October 17, 2022

***RE: Response to Charles Rowley's Peer Review Comments, October 3, 2022
91 and 101 Fearing Hill Road Solar Project – Wareham, MA
ADE Job #3055.02***

Re: Review of Revised Documents – Proposed Fearing Hill Solar Facility
91 & 101 Fearing Hill Road, Wareham, MA

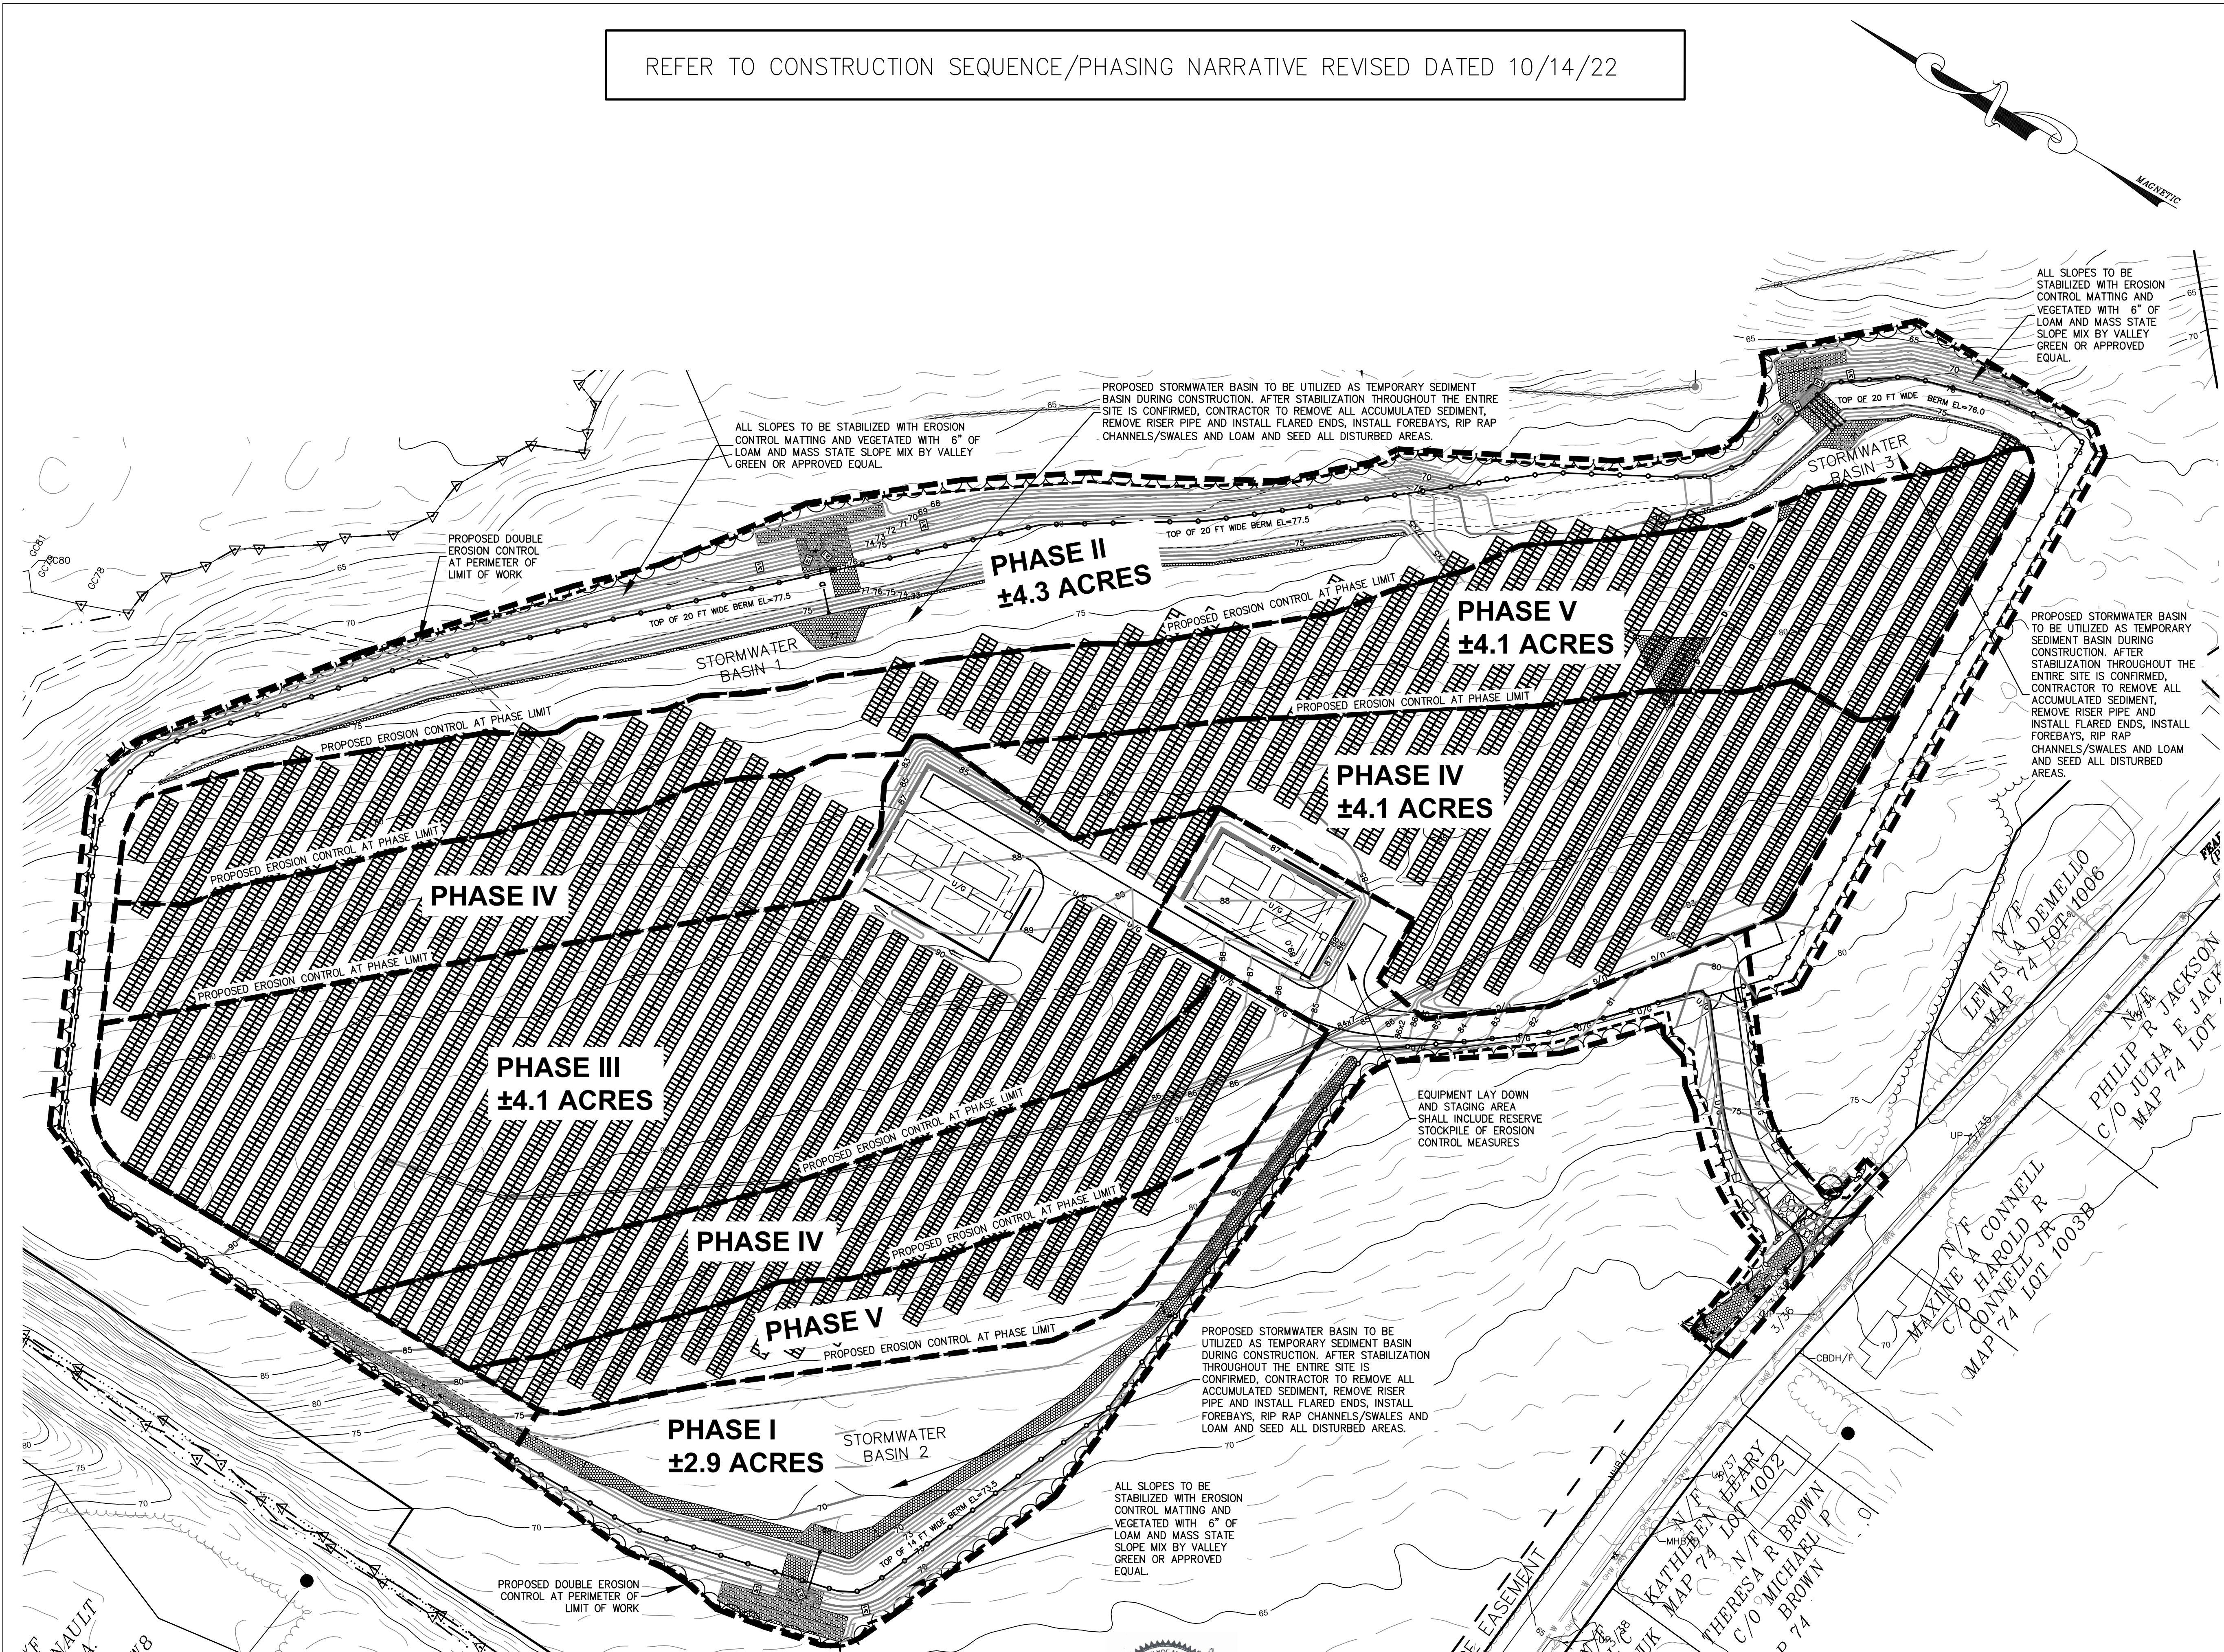
- 2. The plan should show the proposed monitoring well that is to be located east of the access road near Fearing Hill Road. The two additional existing wells should be highlighted and with notations for all three wells indicating that they are to be protected and not disturbed.*

1. *The schedule needs to include notations as to maintenance requirements at every level to protect against erosion of the site. It should include reference to immediate repairs as necessary as well as inspections for the access road, swales and riprap.*

2. *The seeding of temporary cover also should include references to maintenance and re-seeding as necessary while germination is taking place. Corrections to disturbed areas with appropriate stabilization such as bio-degradable or jute netting should be included as well.*

The three monitoring wells to be utilized in the future groundwater monitoring program have been called out on Sheet 5 of the revised site plans, including the 3rd one (MW #6) recently installed near Fearing Hill Road on 10/14/22.

The Construction Sequence/Phasing Schedule has been revised to address repairs, maintenance, re-seeding, and erosion protection as requested, and in addition, it now references the Erosion Control notes and Stormwater Operation and Maintenance notes that are on the site plans. These notes are on the site plans, Sheets 7 and 9.

The Construction Sequence/Phasing Schedule has been revised to address repairs, maintenance, re-seeding, and erosion protection as requested, and in addition, it now references the Erosion Control notes and Stormwater Operation and Maintenance notes that are on the site plans. These notes are on the site plans, Sheets 7 and 9.

REFER TO CONSTRUCTION SEQUENCE/PHASING NARRATIVE REVISED DATED 10/14/22
